Wall thickness variation at Counter dia 14.0 mm in XF1C1 upper bracket

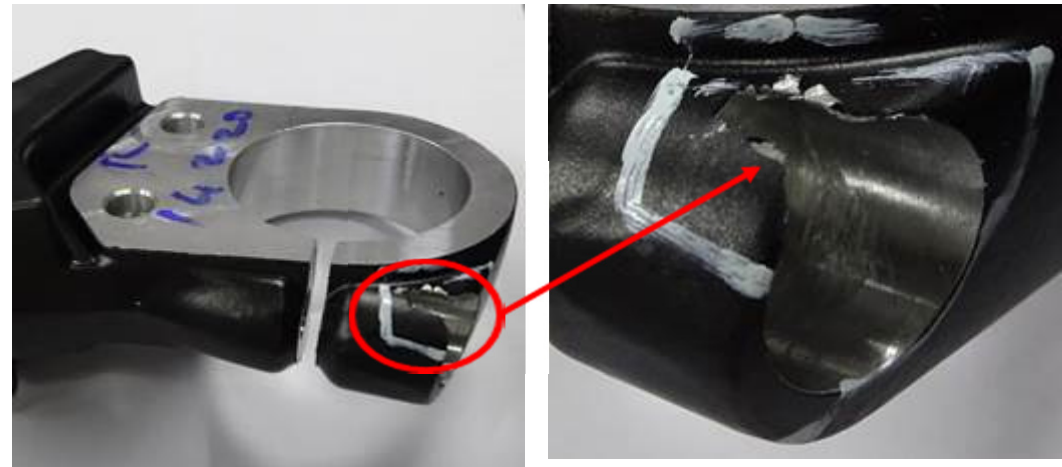
Wall thickness getting shift due to Counter machining reference taken from moving half of casting.

Inspector not aware about wall thickness due to lack of training.

Stage	Action	Trg date	Status
Occurrence	- Machining fixture modification done.	24/3/2023	Completed
Out flow	-Training given to inspector to verify wall thickness	24/3/2023	
	- Wall thickness verification added in hourly inspection report.	24/3/2023	
	-

Stage	Proposed action	Trg date	Status
Occurrence	Outer wall thickness will be increase by 0.5 mm (for safer side)	24/3/2023

Outer wall thickness at defective area has been increase by 0.5 mm to avoid less wall thickness issue.
